# Access Compliance Report

## Public Rights-of-Way

Intersection ID: 23150	Main Street: ALEXANDER_RD	Cross Street: BELLEMEADE_LN	Location: SE
ADA ID: 76A338365D73	Ramp Type: Directional1	Initial Pass/Fail: Fail	Overall Compliance: No
		Severity Score: 1.25

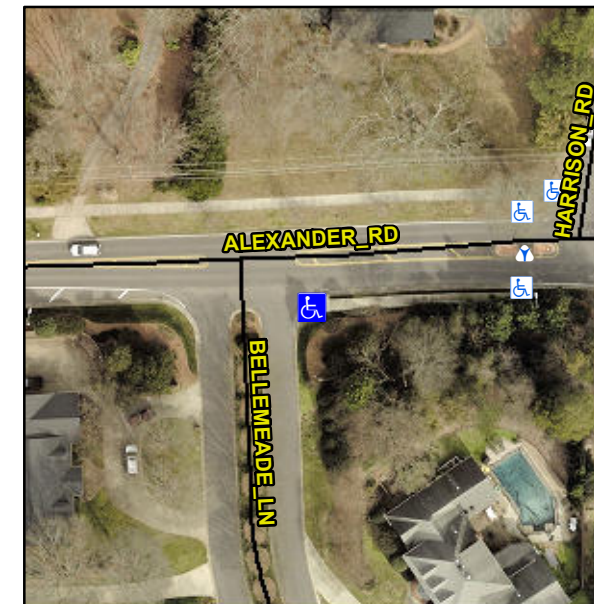
**R304.5.3**

Compliance	Description	Data	Compliance	Description	Data
N/A	Ramp Length (in)	83.0	N/A	Grade Break?	N/A
Yes	Ramp Width (in)	70.5	N/A	Grade Break Slope (%)	0.0
Yes	Ramp Slope (%)	5.9	N/A	Grade Break XSlope (%)	0.0
No	Ramp XSlope (%)	2.4			
N/A	Flare Type LT	N/A	N/A	Flare Type RT	N/A
N/A	Flare Slope LT (%)	N/A	N/A	Flare Slope RT (%)	0.0
N/A	Flare Traversable LT?	N/A	N/A	Flare Traversable RT?	N/A
N/A	Landing Length (in)	0.0	N/A	DWS Provided?	N/A
N/A	Landing Width (in)	0.0	N/A	DWS Contrast?	N/A
N/A	Landing Slope (%)	0.0	N/A	DWS Length (in)	N/A
N/A	Landing X Slope (%)	0.0	N/A	DWS Full Width?	N/A
N/A	Landing Curb? (Y/N)	N/A	N/A	DWS Offset LT (in)	N/A
N/A	Shared Landing?	N/A	N/A	DWS Offset RT (in)	N/A
N/A	Gutter Ponding?	0.0	N/A	Gutter Slope (%)	N/A
N/A	Gutter Lip Ht (in)	0.0	N/A	Gutter X Slope (%)	N/A
N/A	Painted X Walk1?	No		Road Slope (%)	0.7
	X Walk 1 Direction	To W		Road X Slope (%)	5.0
	X Walk 1 Width (in)	N/A		Clear Space?	N/A

**Remove & Replace Entire Ramp.**
